DESCRIPTIVE REPORT

Registry No. H-11403

General Locality Ernest Sound Eastern Passage

Project OPR-O119-FA
Eastern Passage, Alaska
Scale 1:10,000
April 2005

Figure 2: Junction Between H11053, H11403, H11404

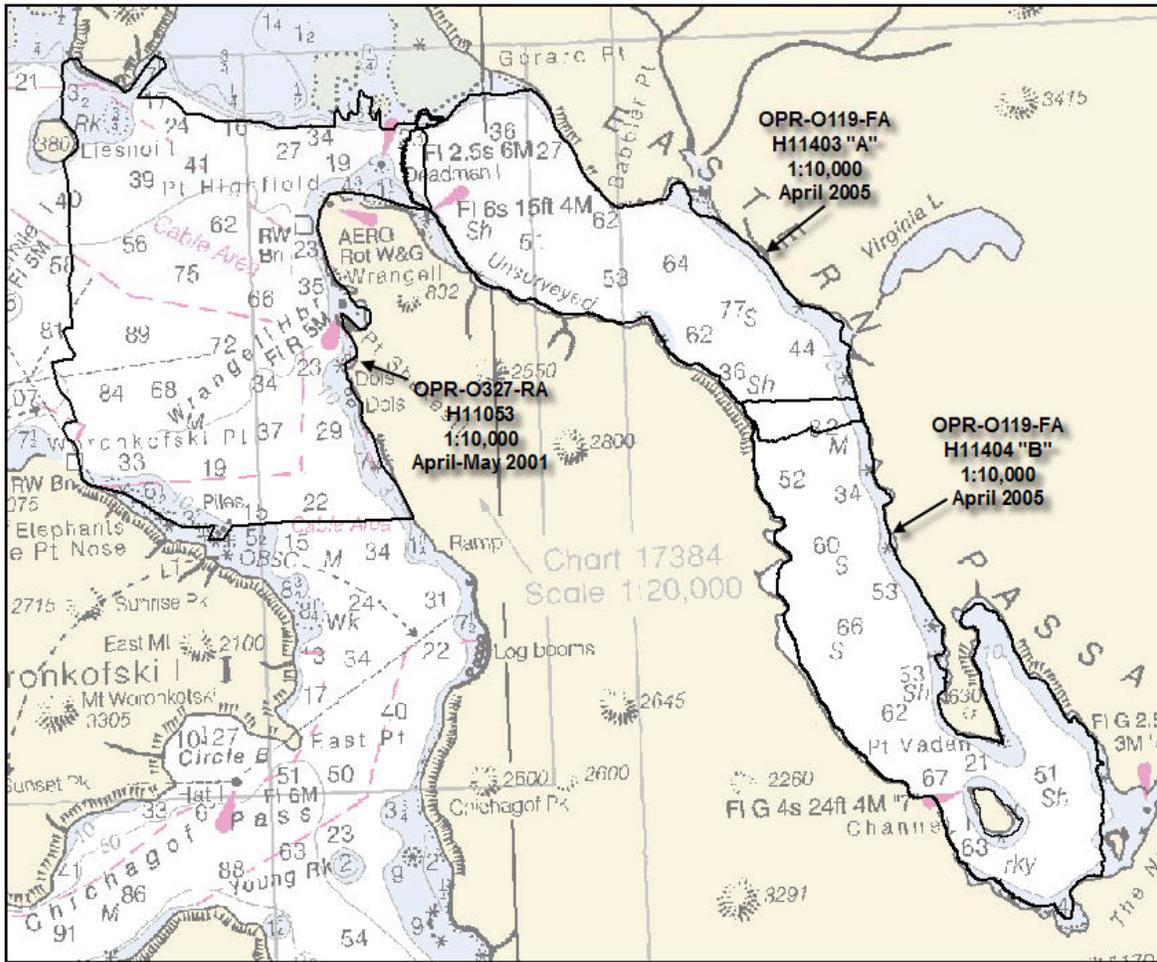
Survey H11403 junctions with H11404, which is Sheet B of the same project. The area of overlap between the sheets was about 500 meters wide. Area surveyed for junction analysis will be reduced on later projects. The data were reviewed in CARIS Subset Editor for consistency and soundings were found to be consistent between the two surveys, meeting the requirements as stated in the *NOS Hydrographic Surveys Specifications and Deliverables*.³

Survey H11403 also junctions with H11053. The area of overlap between sheets was about 300 meters. H11403 preliminary smooth sheet soundings were produced in Pydro from a 2 meter resolution BASE surface and compared in MapInfo with H11053 smooth sheet soundings. H11403 and H11053 data were found to be consistent between the two surveys, meeting the requirements as stated in the *NOS Hydrographic Surveys Specifications and Deliverables*. The exception was the area at the north end of H11403 where H11403 soundings were up to six meters shoaler than H11053 soundings. This is most likely due to the continuing shoaling trend at the mouth of the Stikine River, but may also be due to bottom penetration variation caused by the difference between echosounder system frequencies.⁴

³ Concur

⁴ Concur
